ADDENDUM NO. 2

PROJECT: Renovations to Bolton High School
Alexandria, LA

PROJECT NO: 22022

ISSUED BY: Alliance Design Group, LLC

SHEET A-601

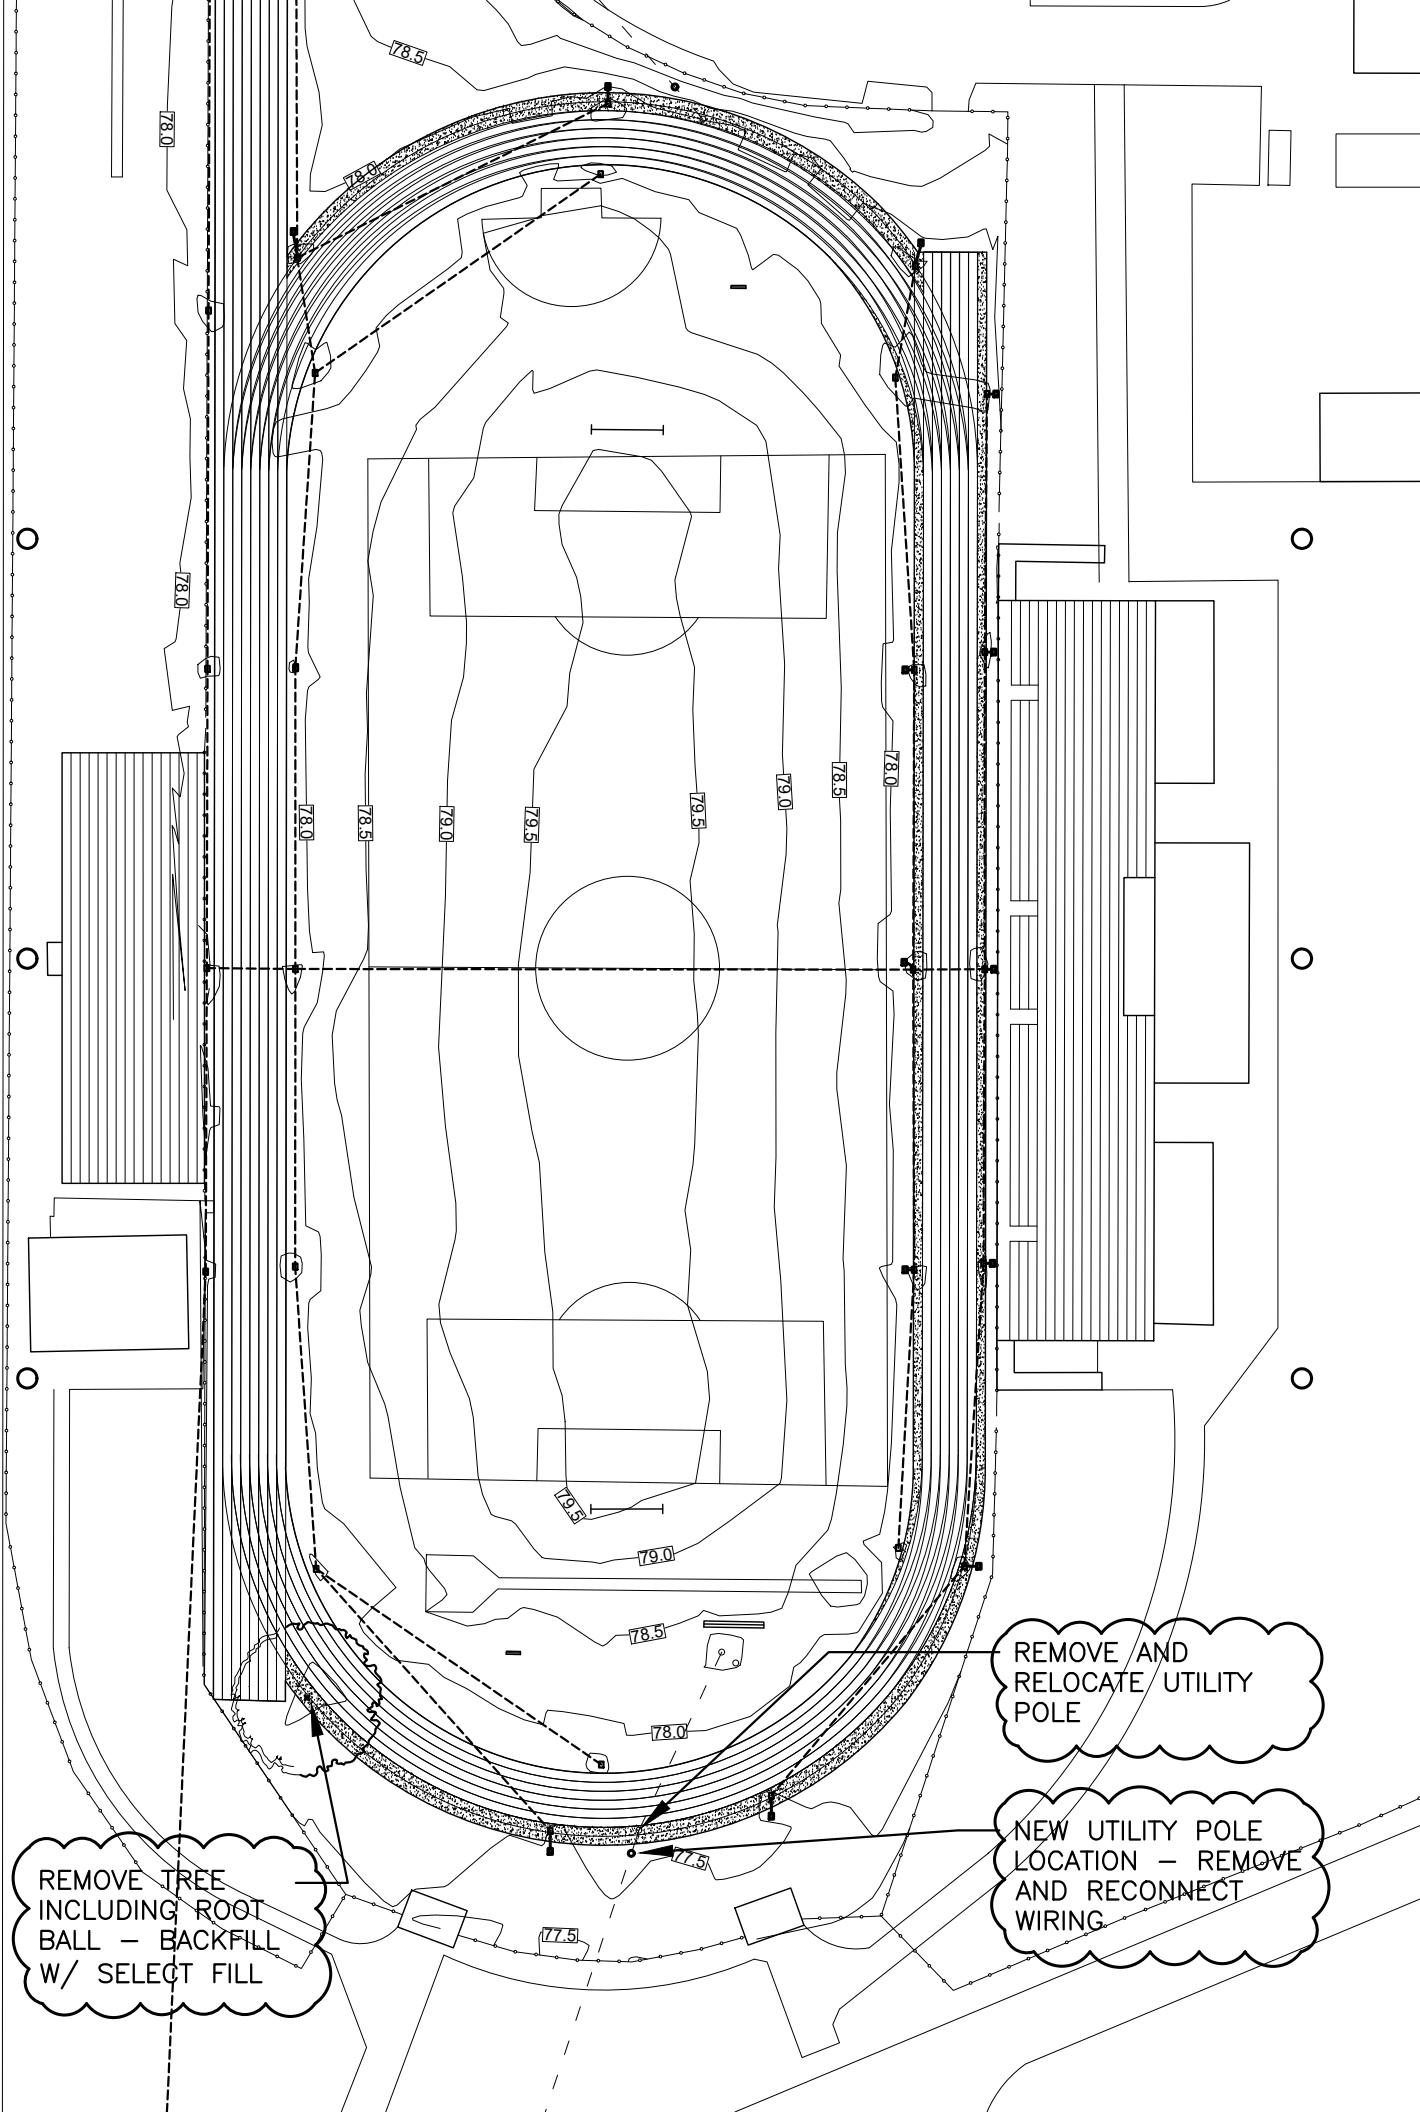
1. Provide new rooms signs at doors 1-34, 1-35, 1-36, 1-37, 1-38, and 1-39.
2. The safety film referenced in the notes section of the Door Schedule shall be 3M Safety Film S70 or equal.
